T18SZ SOFTWARE UPDATE CHANGES

V1.5 - V1.7

This software updates or alters the functions and features noted below. The instructions and information that follow are meant as a supplement to the original instruction manual that accompanied the T18SZ transmitter. Please refer to the original instruction manual where applicable, but replace the steps indicated below with these instructions. Please check to ensure that the update has been installed. 1) Select the System Menu.

When shifting the ON/OFF point

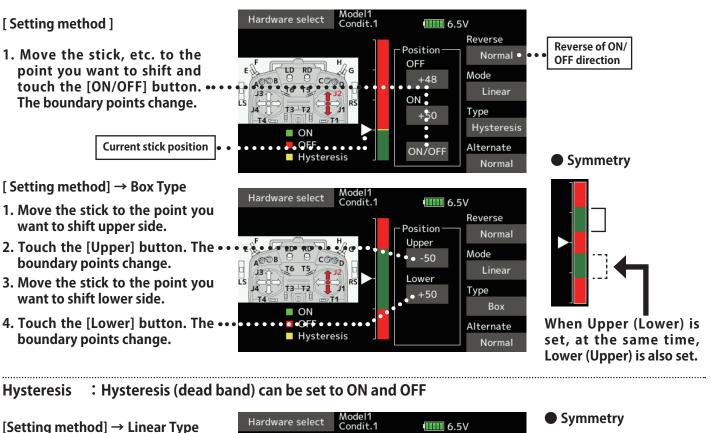
The ON/OFF and hysteresis (dead band) boundary point (there are 2 points: top and bottom) position can be shifted. ON/OFF is possible at a free position.

- 1. Move the stick to the off point you want to shift and touch the [OFF] button. The off points ' change.
- 2. Move the stick to the on point ' you want to shift and touch the [ON] button. The on points change.

When Upper (Lower) is set, at the same time, Lower (Upper) is also set.

Point deletion method

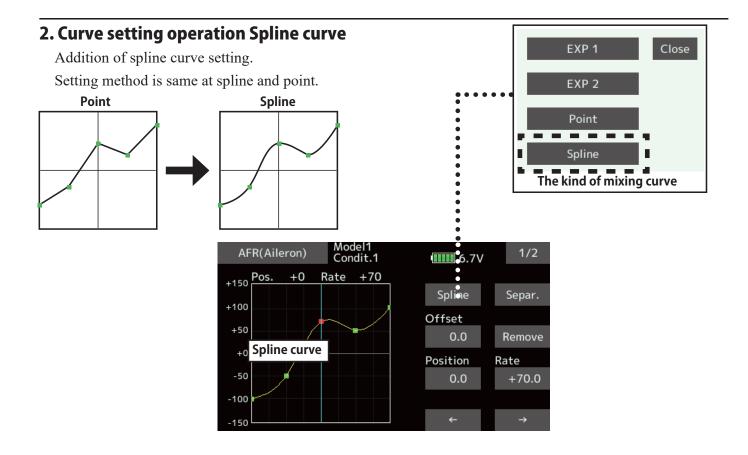
① Use the move between points button [\leftarrow] or [\rightarrow]

point **I** is the selected point.)

- ② Tap the [Remove] button. (The selected point becomes an outlined point □)
- ③ Use the move between points button [←] or

Calling of a current sensor screen.

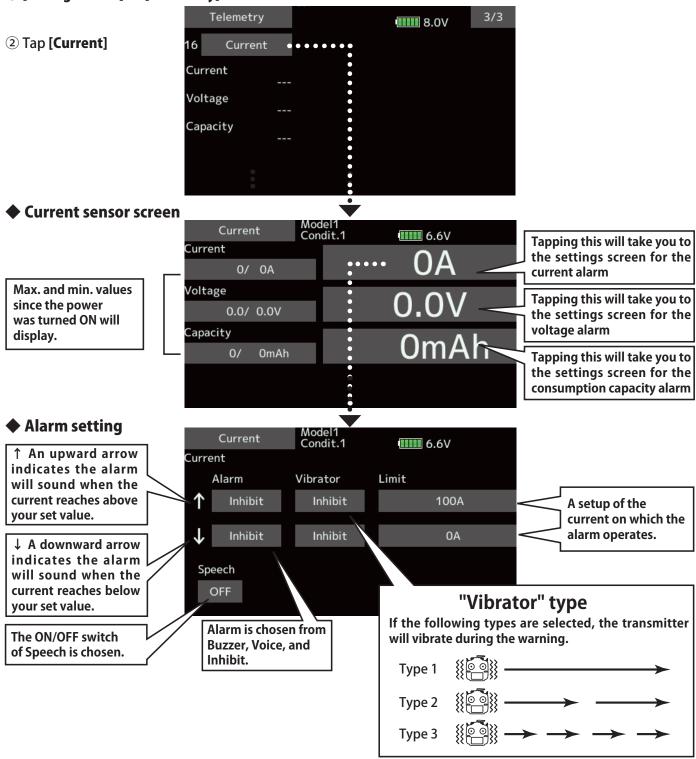
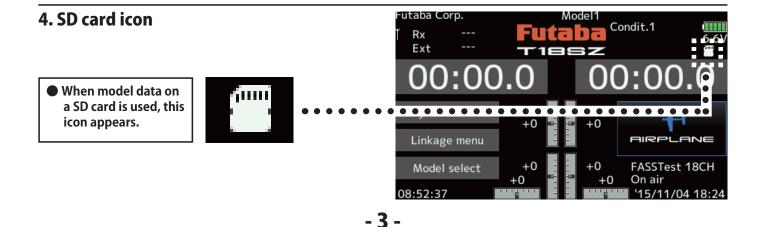
① [Linkage menu] \rightarrow [Telemetry]

🔶 System menu change

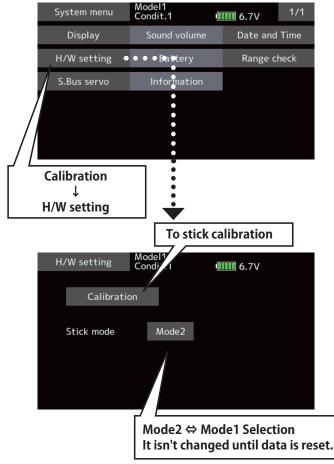
Addition of stick mode function.

Mode 2 or Mode 1 can be chosen.

But, it isn't changed until data is reset.

To change the mode the stick ratchet must be changed. Request that this be done by Futaba Service. (Charged modification)
